CONSTRUCTION PERMIT

RE: Cemetary Road Sanitary Sewer

PROJECT NO: S88-56

Re: Sanitary Sewer Reconstruction
Cemetery Road/Lisbon, Iowa

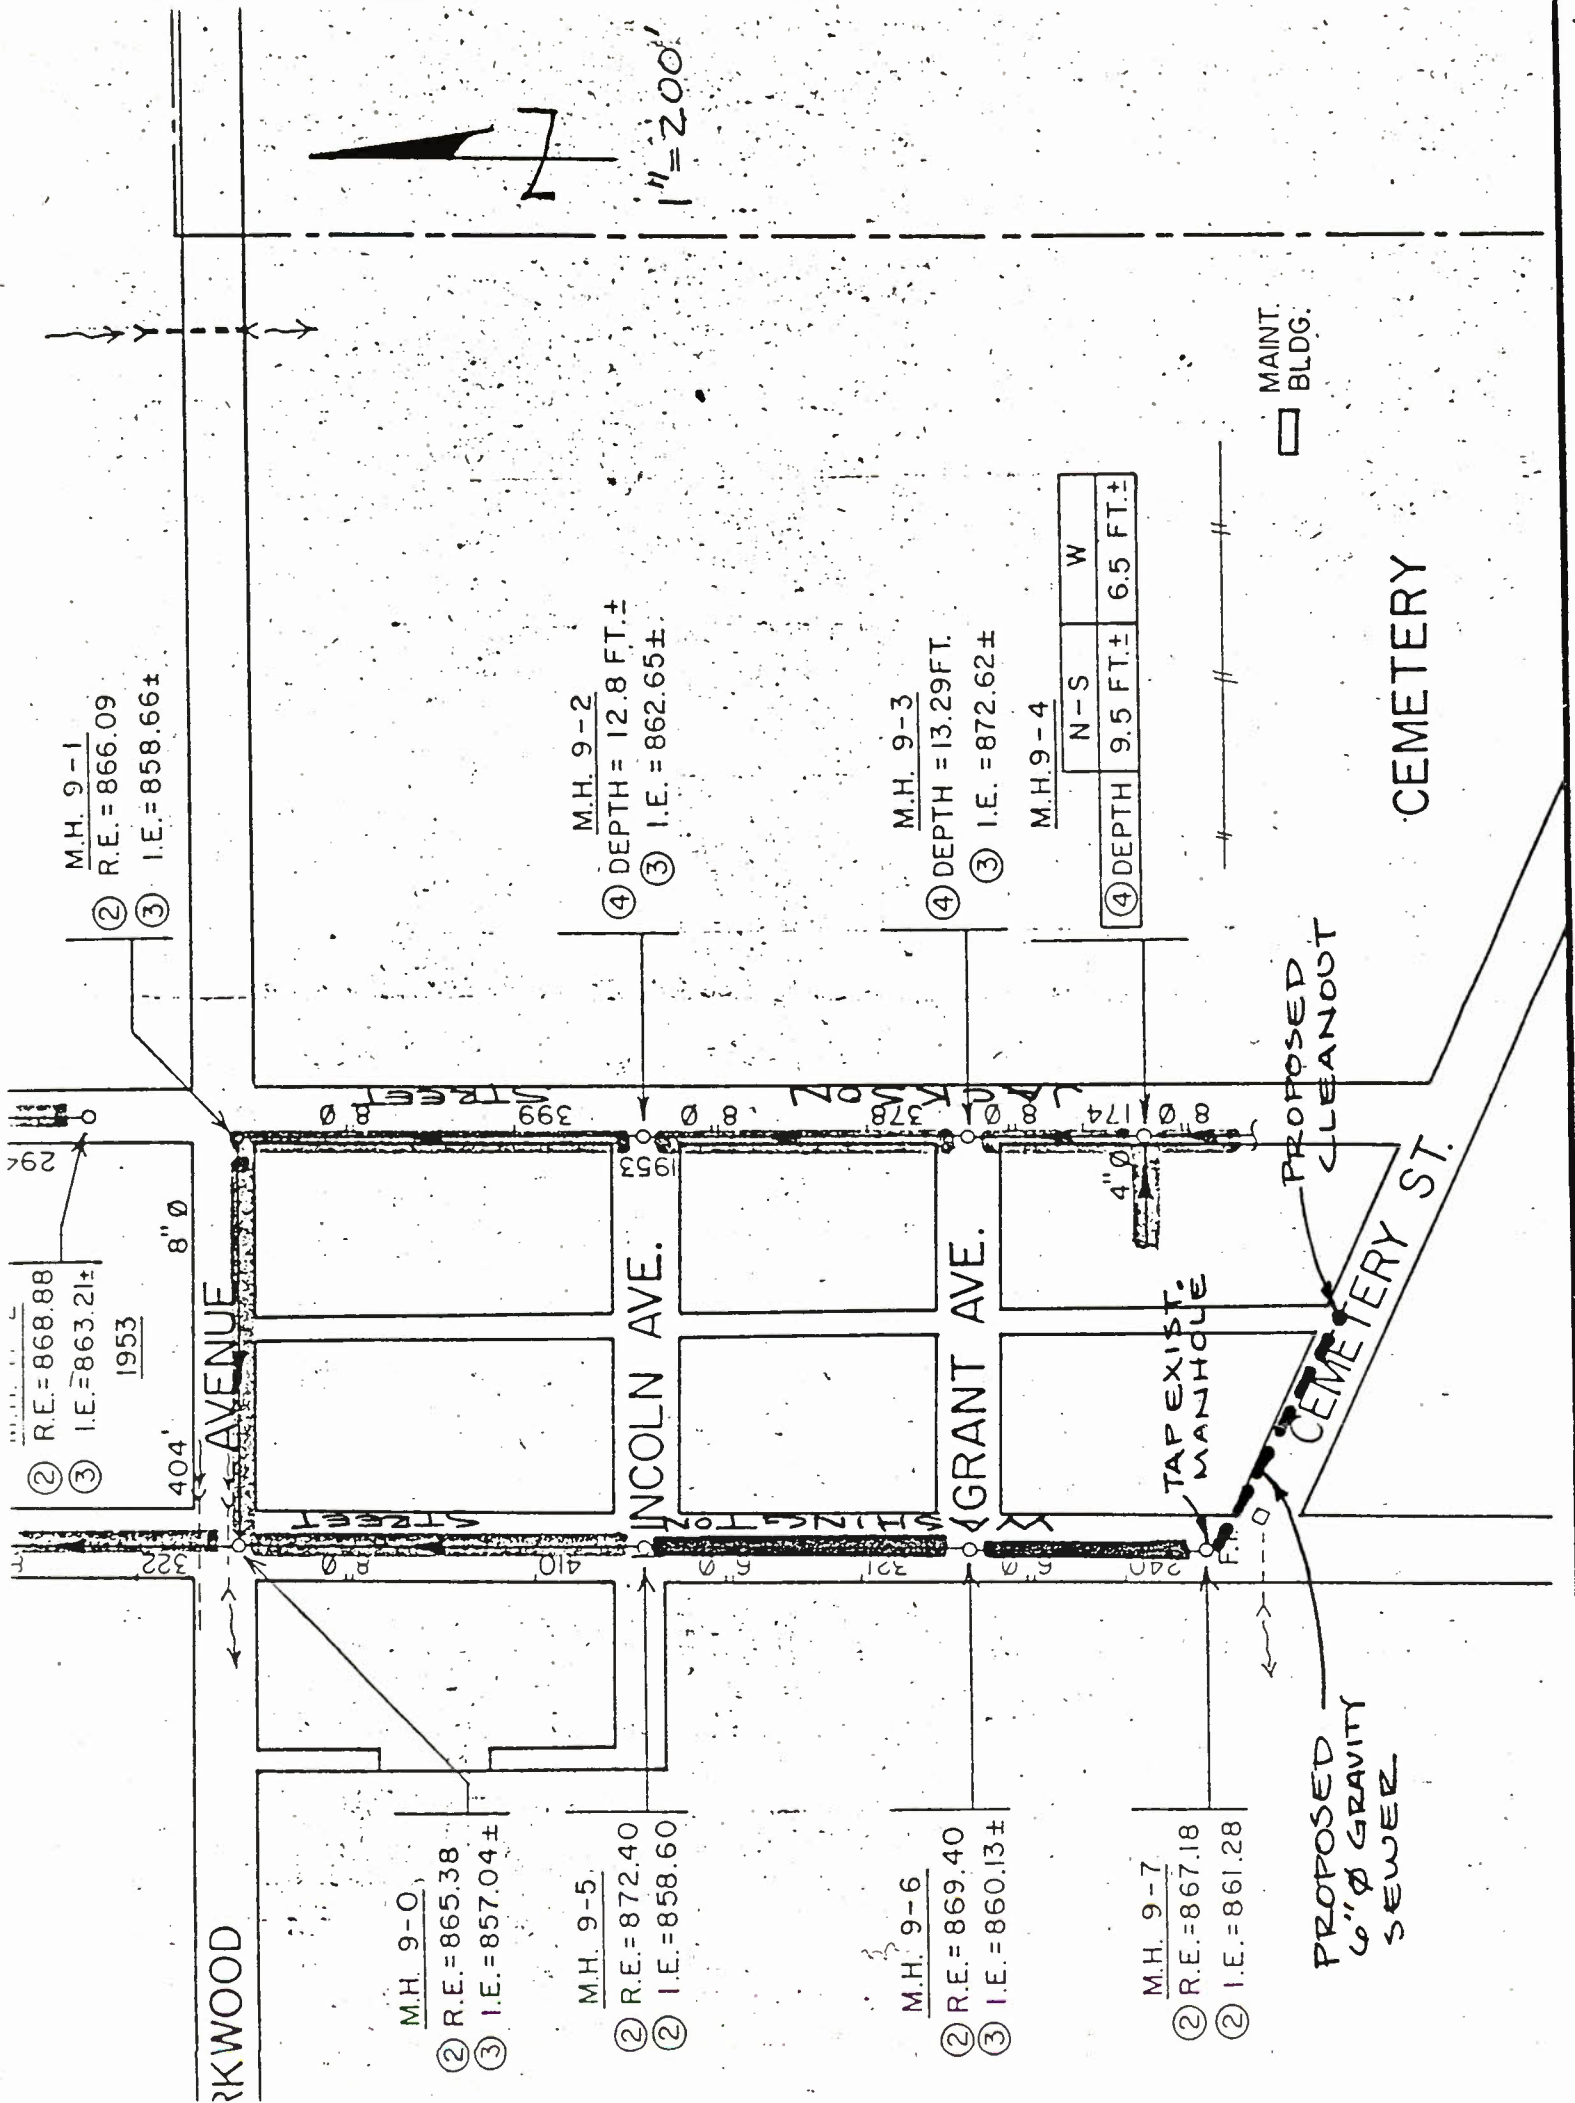
On behalf of the City of Lisbon, we are requesting variance from the Chapter 12 design standard to allow for:

1. A 6" diameter sewer in lieu of 8" per Section 12.5.1.
2. Sewer construction at a minimum grade of 0.34%, which will provide for a minimum velocity of 1.5 feet per second. Per Section 12.5.3.
3. A sewer cleanout at the terminal point rather than a sanitary sewer manhole. Per Section 12.5.7.

A sketch plan and revised Schedule C was submitted with our letter of February 5, 1988 as you earlier requested, but we have attached a revised Schedule C which shows the proposed grade at 0.34% minimum. We trust that this letter, together with previous submittals will allow you to issue a construction permit including the variances requested.

The requested variances from our design standards to permit the use of 6-inch diameter sewer on a minimum grade of 0.34 ft/100 ft and terminate the sewer line with a cleanout are hereby granted.

6" approved to replace
existing 4" sewer
serving 4 homes
